Planning Commission Regular Meeting

City of Excelsior
Planning Commission

ITEM REPORT**To:** Planning Commission**From:** Julia Mullin, Community Development Director, Jess Long, City Planner**Meeting Date:** March 23, 2026**Department/Office:** Community Development**Item Name:** 35 Center Street - Variance Application (PC No. 2026-03)**Summary:**

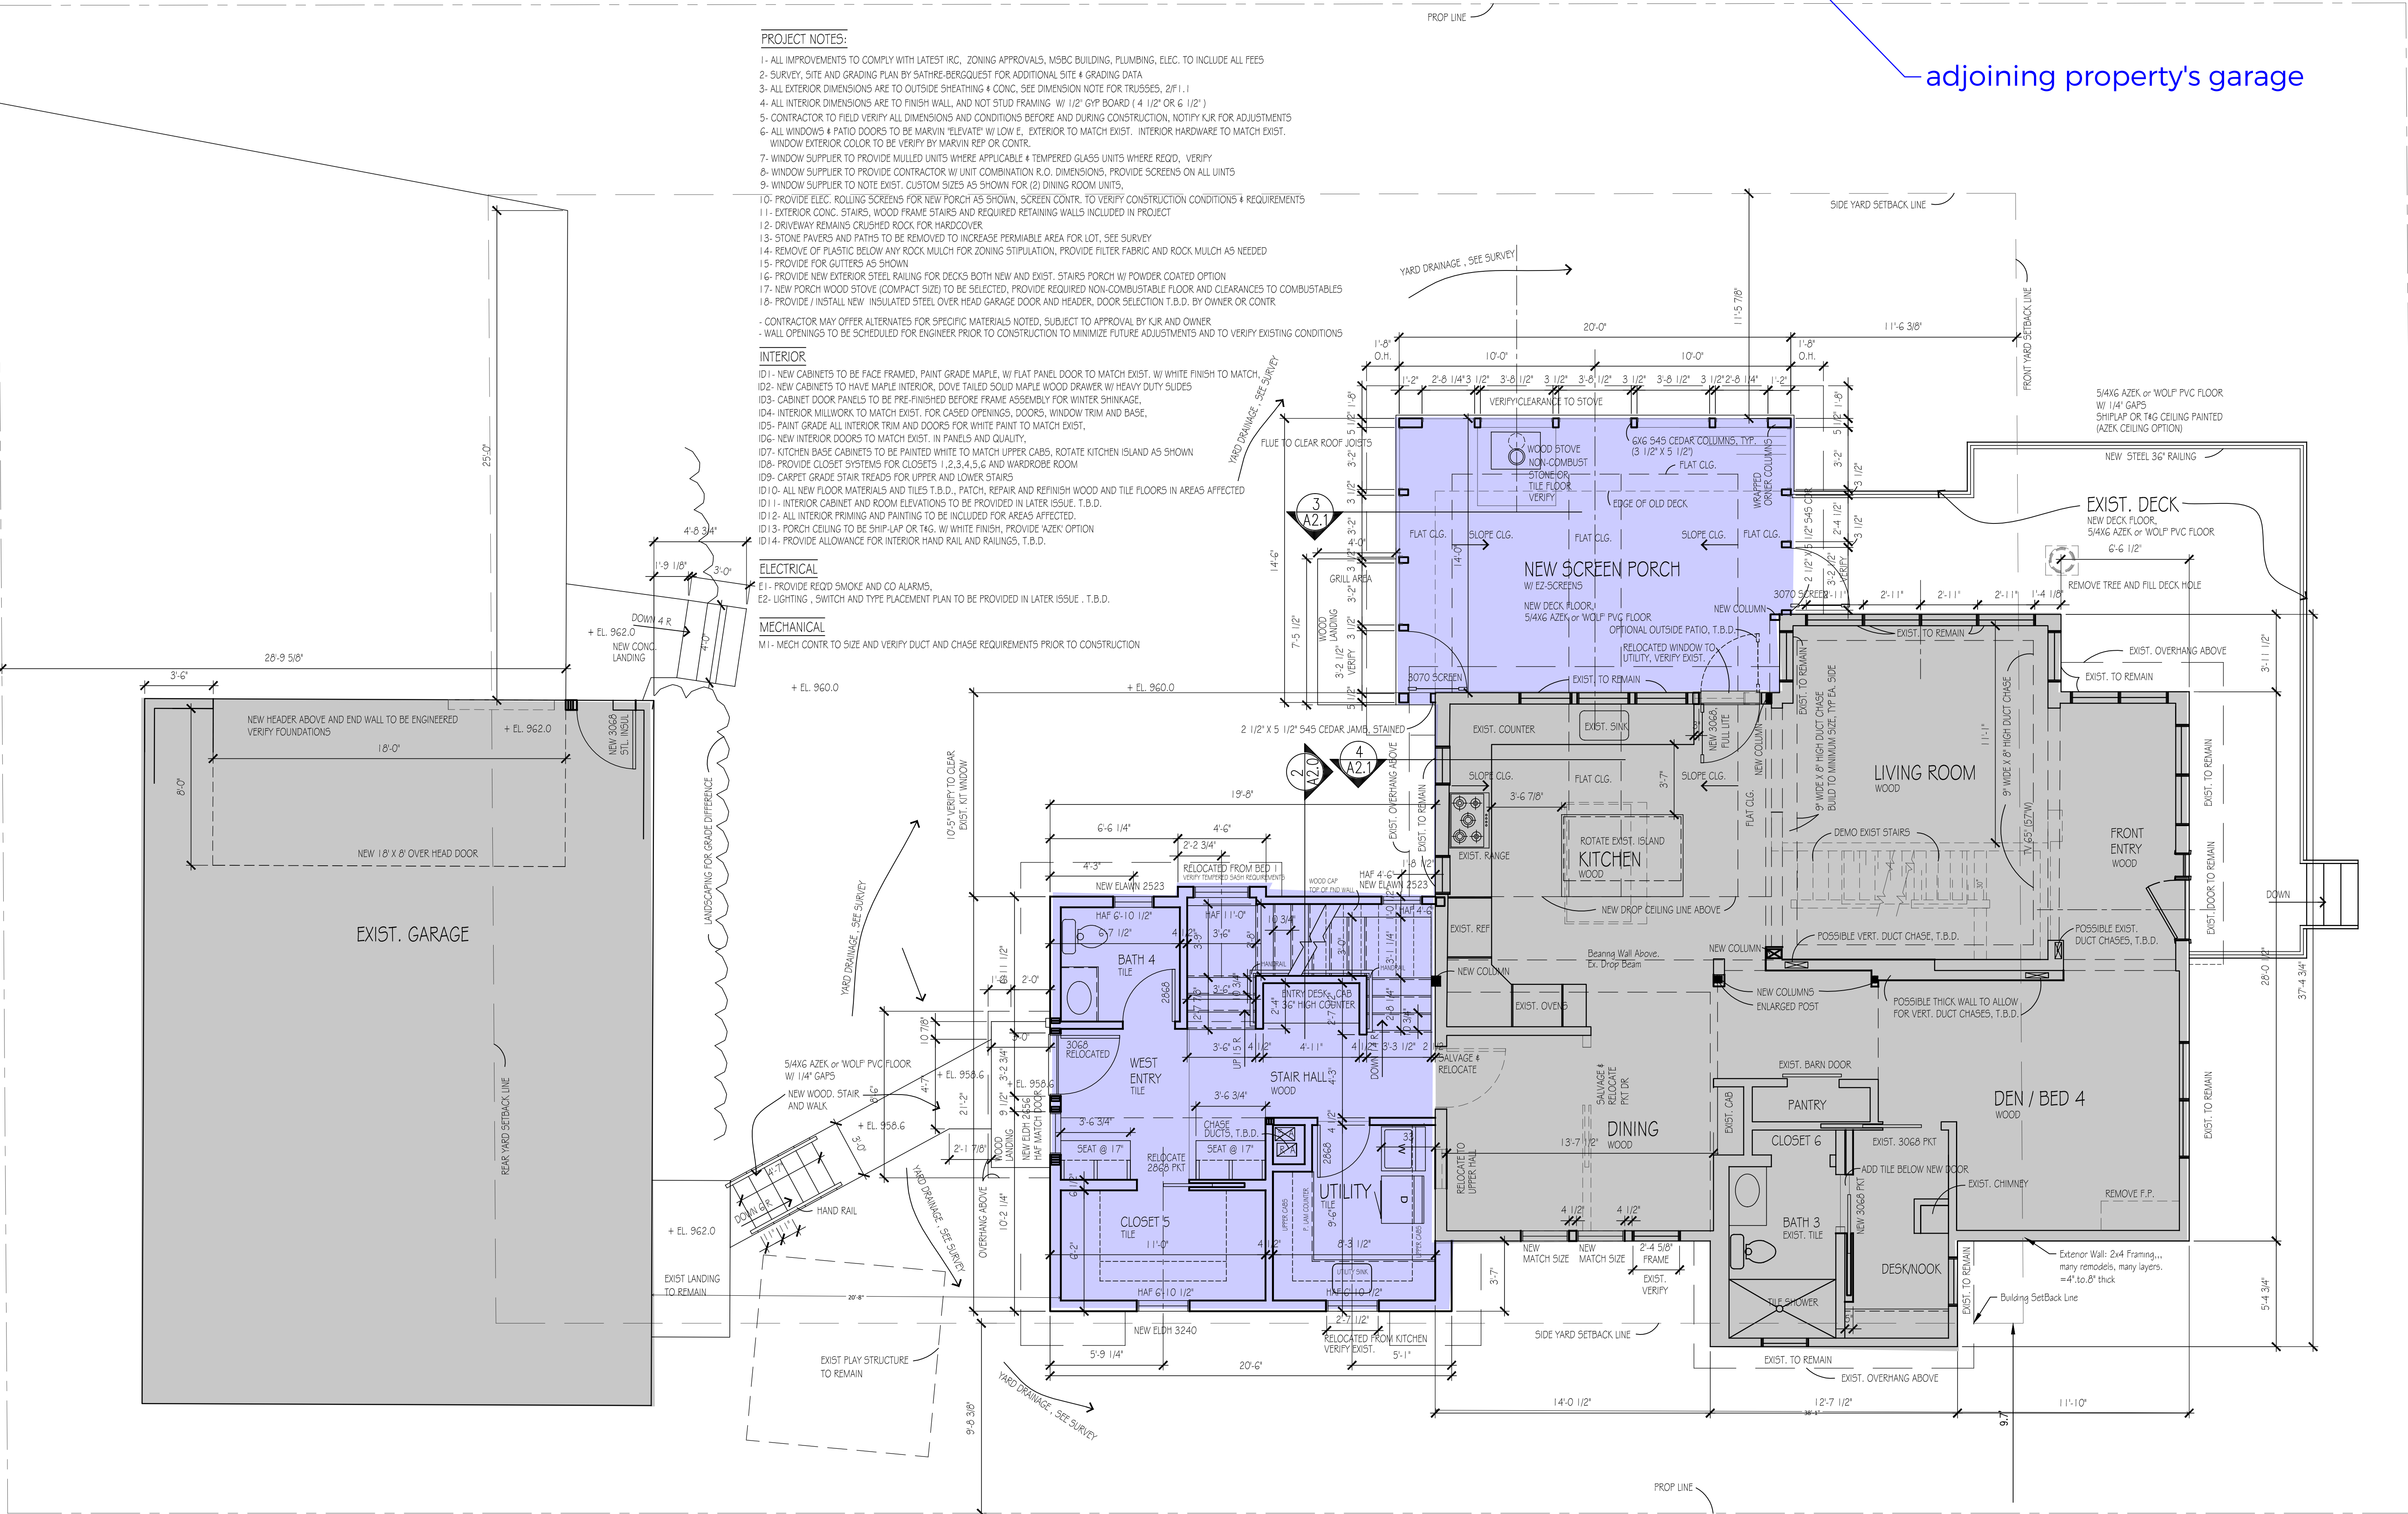
Neither addition affects the front elevation of the house. The screen porch addition connects to an existing low deck that extends to the front of the house

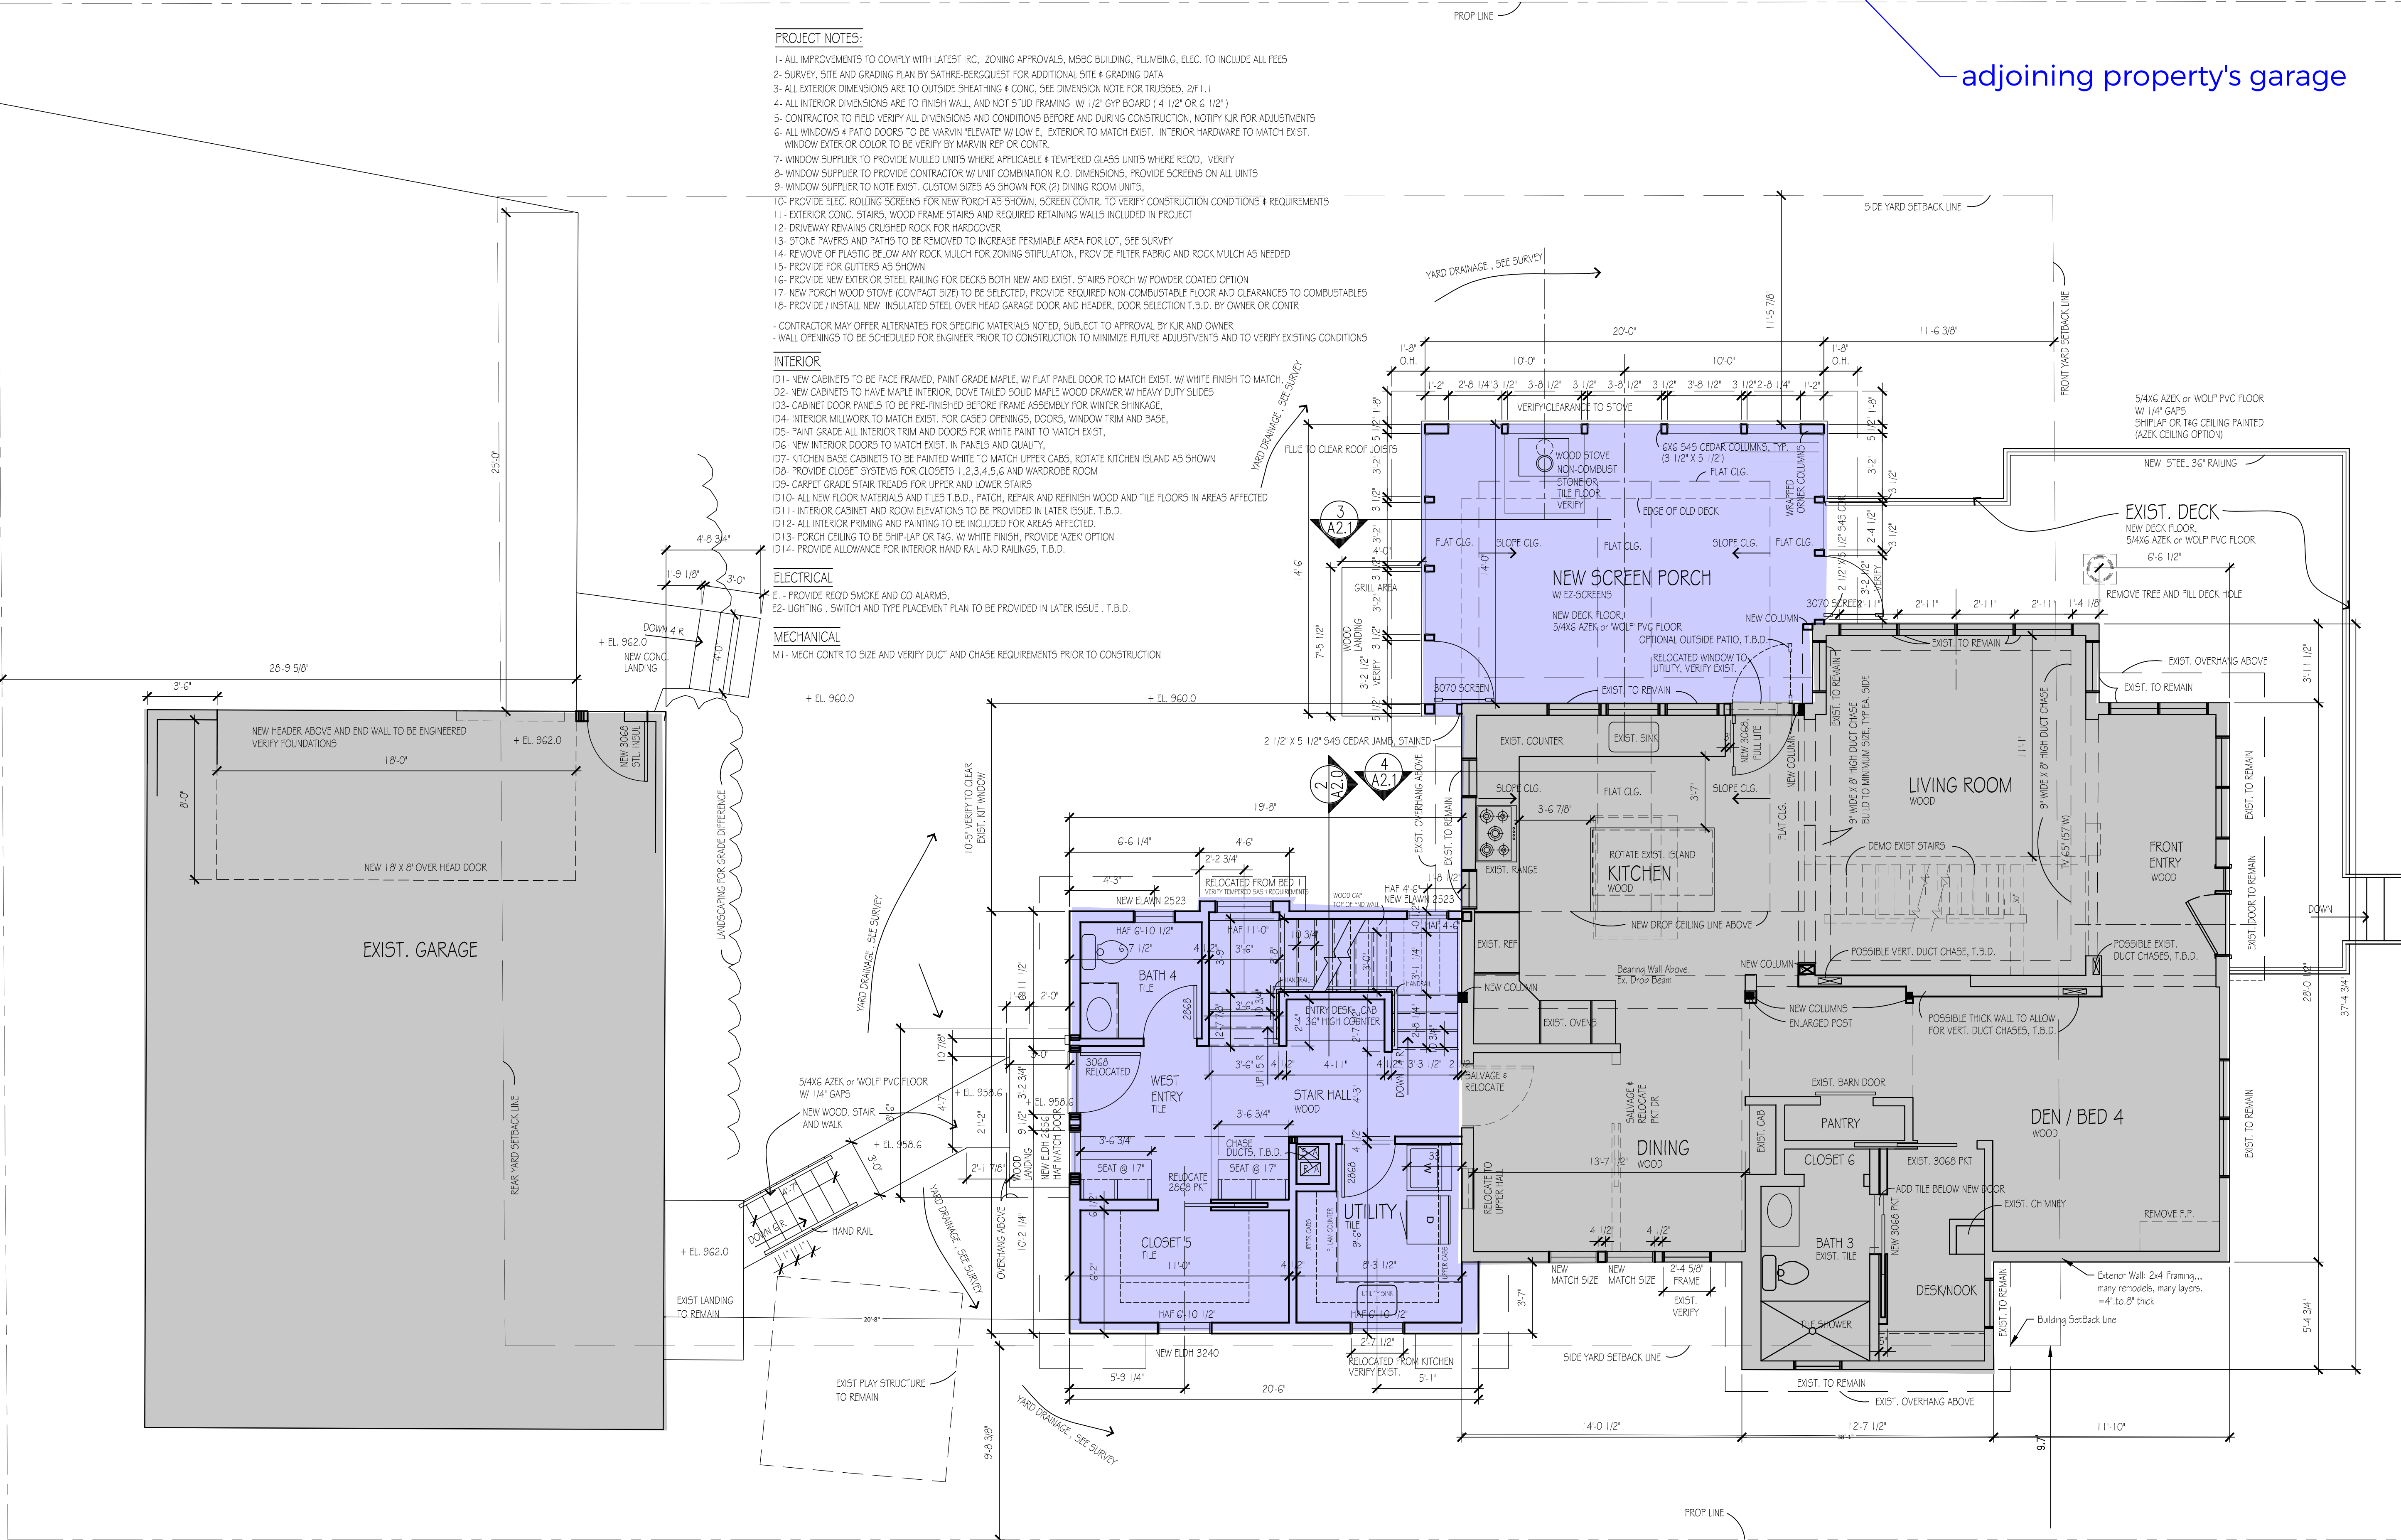
The rear-yard addition has its roof aligned on axis with the existing house's roof lines, with its walls setback 9-8 from the adjoining property line. The side-yard addition (with more outdoor activity) faces the deeper side of the lot and is buffered from the neighbor to the right/north (274 Lake) by the neighbor's garage.
